Model: Model C-C1		Date: 13-Apr-04	No.: RB173001
Subject: Service Manual Correction		Prepared by: A. Ishiyama	
From: 1st Technical Support sec. Service Support Dept.			
Classification:	<input type="checkbox"/> Troubleshooting <input type="checkbox"/> Mechanical <input type="checkbox"/> Paper path <input type="checkbox"/> Other (      )	<input type="checkbox"/> Part information <input type="checkbox"/> Electrical <input type="checkbox"/> Transmit/receive	<input type="checkbox"/> Action required <input checked="" type="checkbox"/> Service manual revision <input type="checkbox"/> Retrofit information

Model: Model C-C1		Date: 2-Jul-04	No.: RB173002
Subject: Machine Firmware History		Prepared by: A. Ishiyama	
From: 1st Technical Support Sec. Service Support Dept.			
Classification:	<input type="checkbox"/> Troubleshooting <input type="checkbox"/> Mechanical <input type="checkbox"/> Paper path <input type="checkbox"/> Other (      )	<input type="checkbox"/> Part information <input type="checkbox"/> Electrical <input type="checkbox"/> Transmit/receive	<input checked="" type="checkbox"/> Action required <input type="checkbox"/> Service manual revision <input type="checkbox"/> Retrofit inf

## 2. PREVENTIVE MAINTENANCE

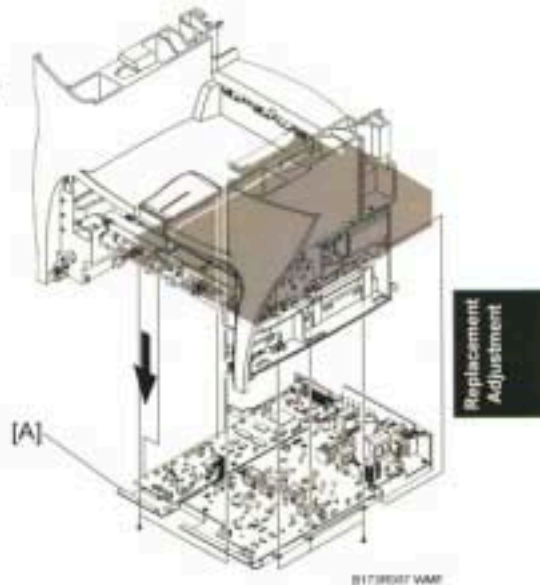
Section	Page	Correction
TABLE OF CONTENTS	iv	Some section numbers and page numbers have been corrected.
2. PREVENTIVE MAINTENANCE	2-1	The PM table has been corrected.

Component	Replacement Cycle	Done by
Scanner	ADF Rubber	20,000 Pages	Service
	ADF Pick-up Ass'y	60,000 Pages	Service
Printer	Friction Pad	60,000 pages	Service
	Paper Feed Roller	60,000 Pages	Service
	Transfer Roller	60,000 Pages	Service
	Fuser	60,000 Pages	Service

### 3.10 MAIN PBA (MAIN BOARD)

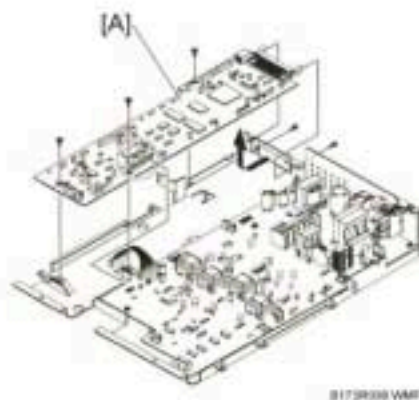
3. REPLACEMENT AND ADJUSTMENT	3-17	3.10 MAIN PBA (MAIN BOARD): A note has been added.
	3-20	3.13 FAN: A procedure has been corrected. A caution has been added.

**NOTE:** 1) Print out the system data list in Tech mode to keep programmed data before you do the replacement procedure.  
2) Do the "Clear All Memory" in Tech mode (➡ 5.2.3) after you finish the replacement procedure.

## < B173>

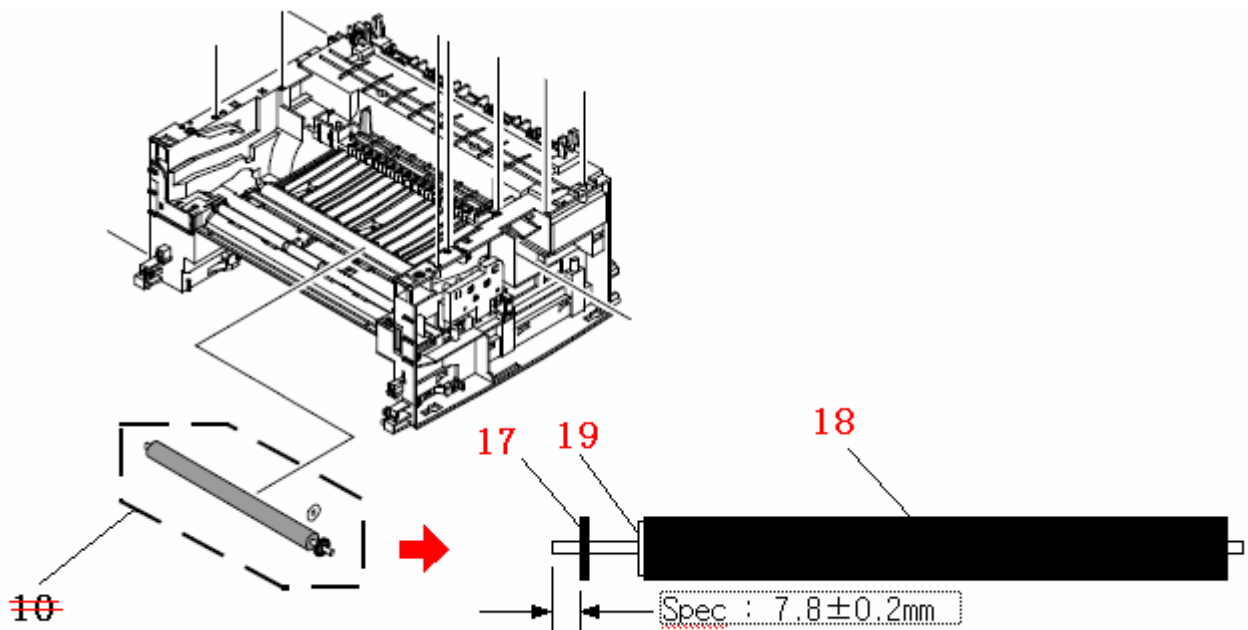
**Change:** P/N B1739513 was divided into three separate parts.

**Reason:** The parts vendor stopped supplying P/N B1739513 as an assembly.

Old Part Number	New Part Number	Description	Q'ty	Int	Page	Index	Note
B1739513	B1739801	GEAR - TRANSFER	1	O/O	3	10→17	
	B1739802	ROLLER - TRANSFER	1			10→18	
	B1739803	SPACER - TRANSFER	1			10→19

## <H914/H915>

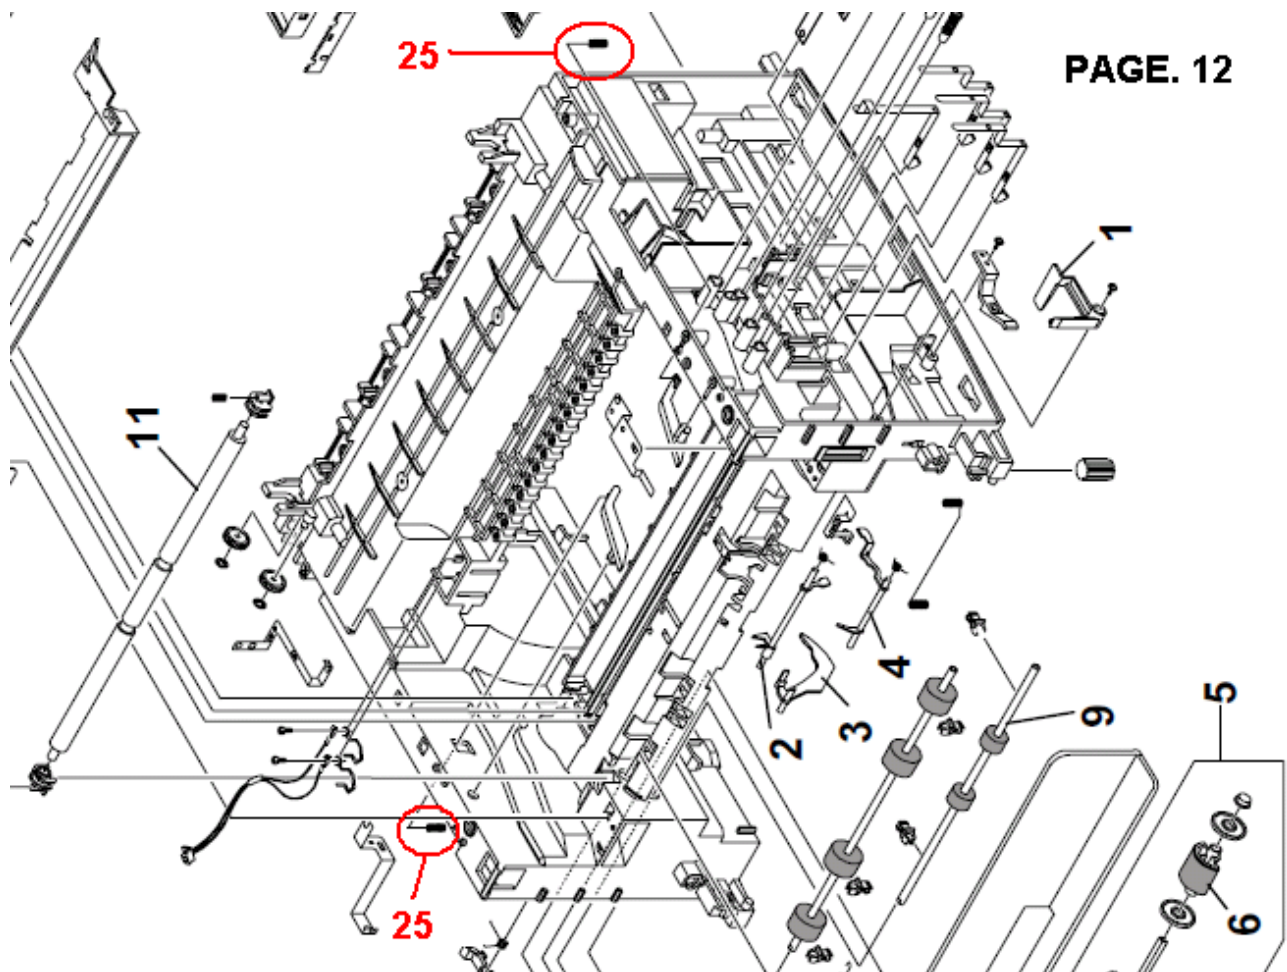
New service part is added.

Request from the field.

New Part #	Description	Q'ty	Int.	Page	Index	Note
G1861203	SPRING - GUIDE	2	-	13	25

Page 14 of the Parts Catalog

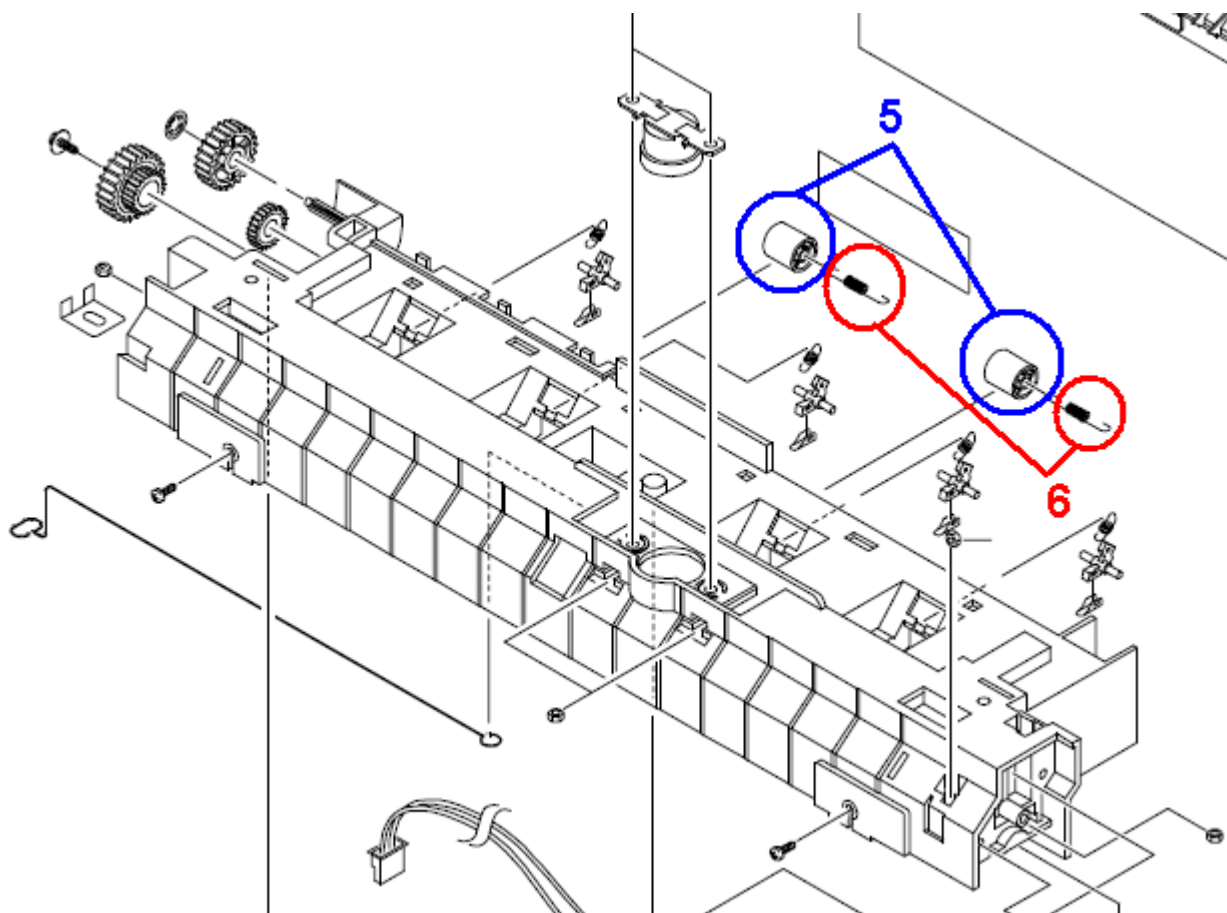
Two service parts are newly added.

Request from the field.

Part Number	Description	Q'ty	Page	Index	Note
B1739805	ROLLER EXIT	2	14	5	
B1739806	SPRING FUSER EXIT	2	14	6

Page 12 of Parts Catalog

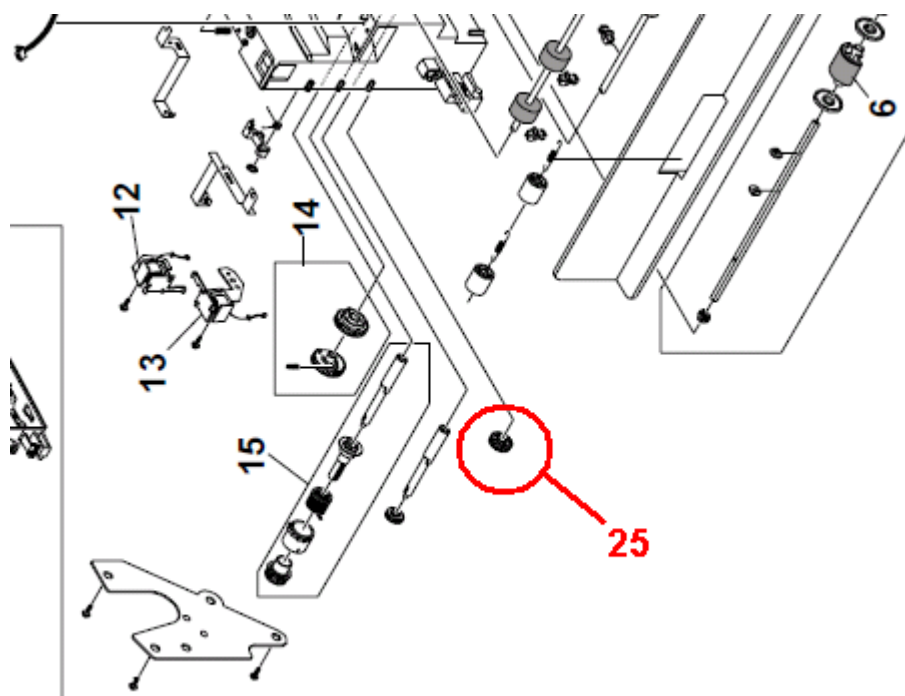
The following part is added.

Request from the field.

New Part #	Description	Q'ty	Page	Index	Note
G9601101	IDEAL GEAR MA ASS'Y (RoHs)	1	13	25
